# 100GBASE-KP4 TX (comment #222, 221/95)

January 2013

# Transition Times Options (Comment #222)

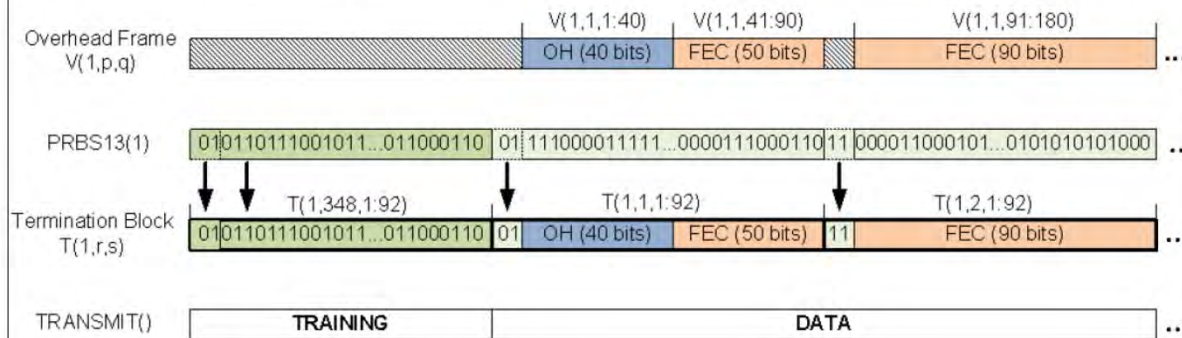
- QPRBS13 (per 94.2.11.3) has sufficient runs of +/-1 PAM4 symbols for direct measurement

Symmetric Run length	Lane 0 Count	Lane 1 count	Lane 2 count	Lane 3 count
1	907 / 943	1009 / 1031	991 / 1003	937 / 981
2	50 / 61	68 / 57	59 / 80	59 / 58
3	2 / 3	4 / 3	2 / 3	4 / 4
4	0 / 0	0 / 0	0 / 0	0 / 0

- In Draft 1.3, replace 2<sup>nd</sup> and 3<sup>rd</sup> paragraphs in 94.3.12.5 with:
  - The test pattern is quaternary PRBS13 per 94.2.11.3. The transitions within sequences of three -1 PAM4 symbols followed by three +1 PAM4 symbols and three +1 PAM4 symbols followed by three -1 PAM4 symbols are measured. The 0% level and the 100% level are as defined by the OMA measurement procedure (see 68.6.2).
- Update last paragraph to use a value for TBD:
  - The transition times shall be greater than or equal to **18** ps when transmit equalization is disabled. Transmit equalization may be disabled by asserting the preset control defined in Table 45–60 and 45.2.1.81.3.

Figure 94-9—Transition from alert to data mode

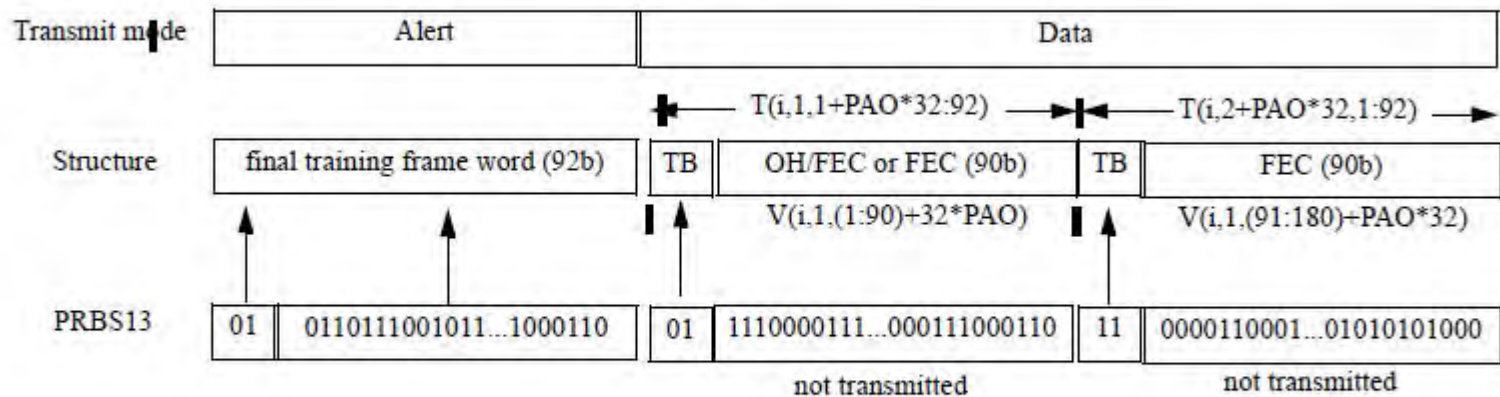
# ALERT Comment

- Add note to Figure 94-9: “The values for the PRBS13 are specific to a transition with a PAO of zero on Lane 0. The values will be different for other PAO values or lane number.”
